Permit Number 2018-P-1154-PP
Job Address: Shadowglen Phase 3 Section 1 & 2 Preliminary Plan, Manor, TX. 78653

The first submittal of the Shadowglen Phase 3 Section 1 & 2 Preliminary Plan (*Preliminary Plan*) submitted by Kimley Horn and received on February 10, 2023, have been reviewed for compliance with the City of Manor Subdivision Ordinance 263B.

RE: *Preliminary Plan for Shadowglen Phase 3 (Permit No. 2018-P-1154-PP)*
 Section 1 & 2
 Manor, Texas 78653

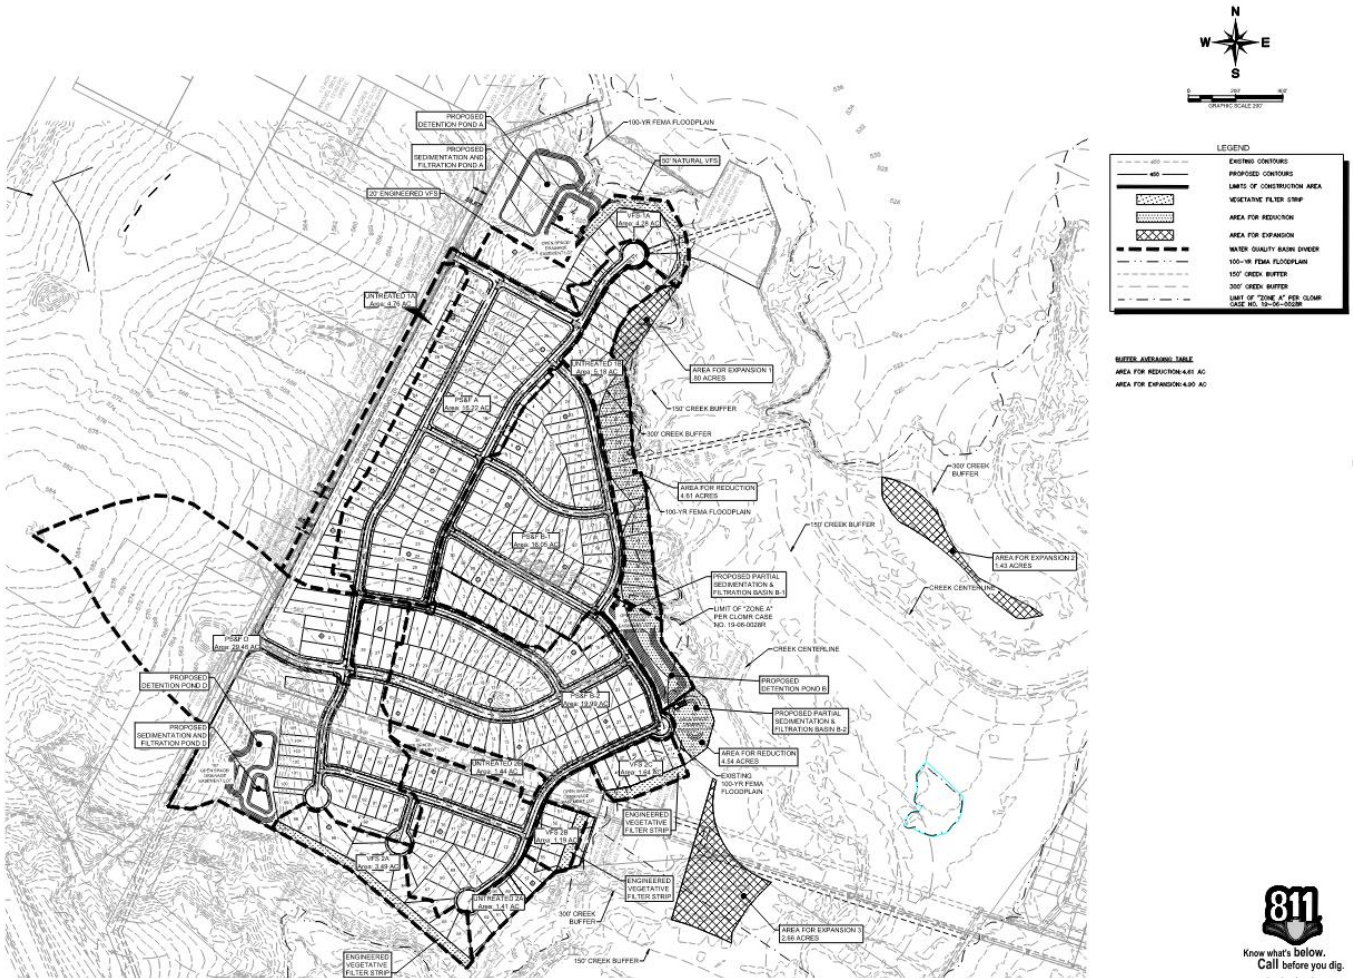
5. An exception request would need to be approved by the Division Director under 482.941.j.7. for the waterway buffer encroachments noted.

Please submit your request for approval.

Response: As discussed in our previous comment response a buffer averaging is proposed for the residential lots and Pond B located within the 300' setback per COA ECM 1.5.2.D. The 4.61ac area of reduction shown on Exhibit B will be averaged with three areas of expansion that account for a total of 4.9 acres. See exhibit G below and on sheet 12 of the prelim plan.

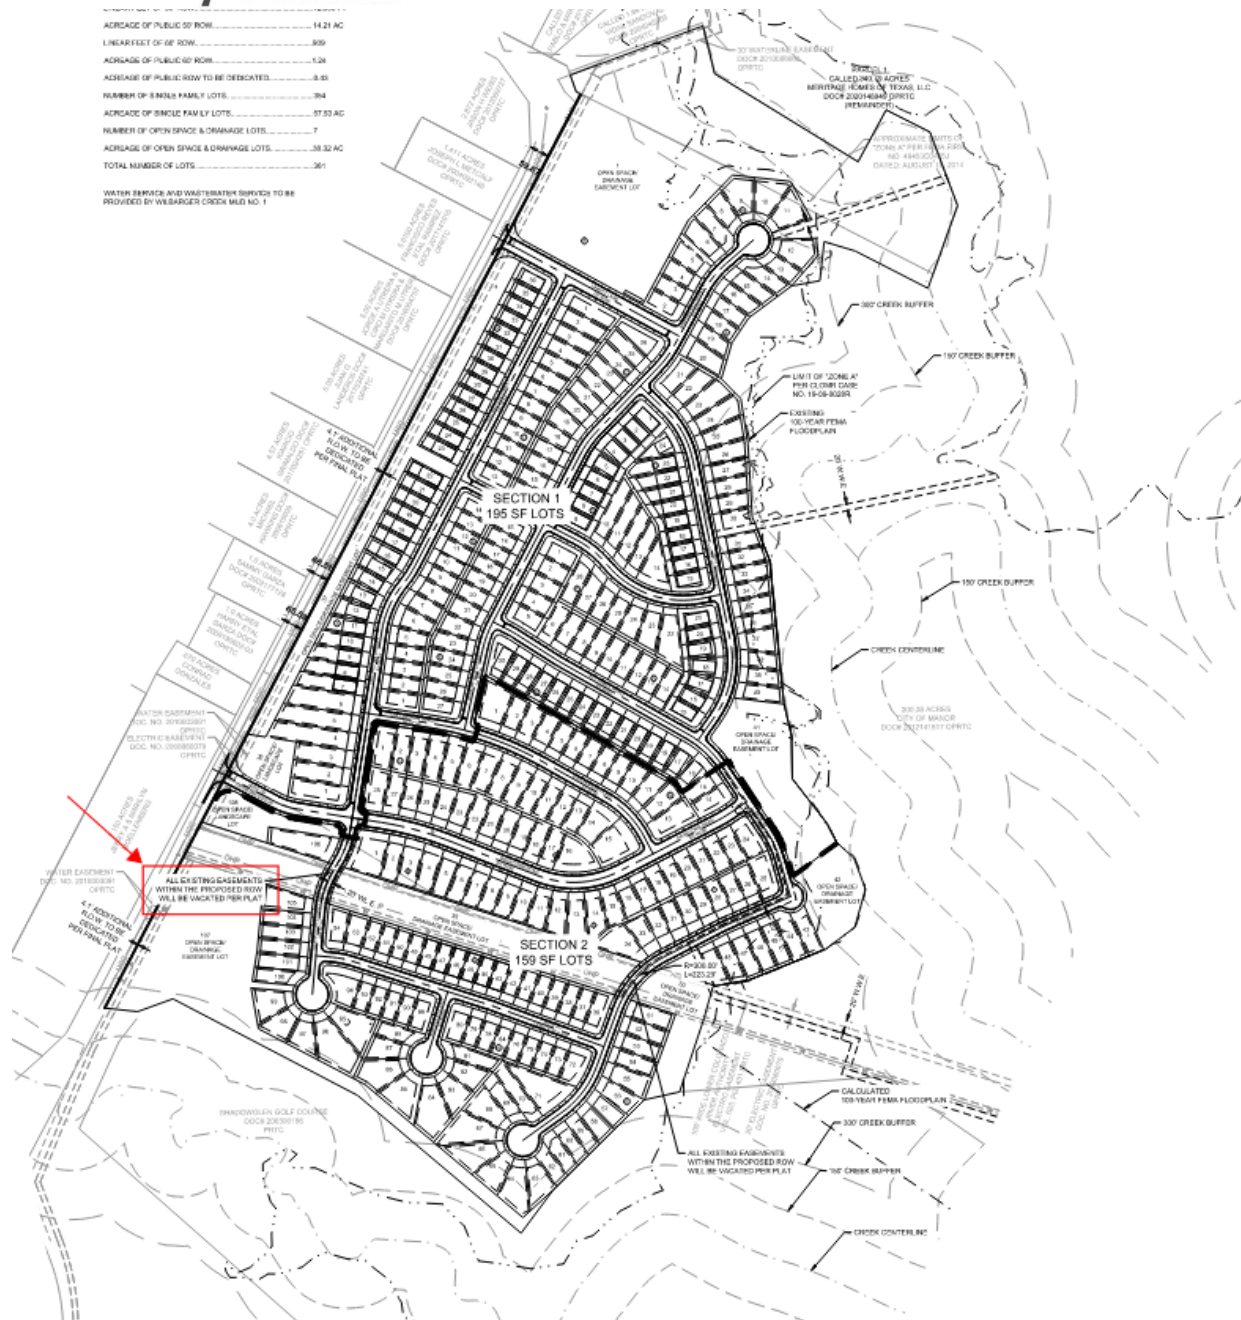
Comment 16: Designate any existing easement crossing a proposed right-of-way as to be vacated on the plan. Rights-of-way must be clear of any encumbrances or entitlements in order to be accepted by Travis County for maintenance. 5/23/19 – Revise preliminary plan as requested.

Update comment 1/23/23: Please confirm the location of the note; I did not find it on the Preliminary Plan.

Response 16: Vacation note has been added to the preliminary plan.

Response: Acknowledged. The vacation note is shown below on the overall preliminary plan.
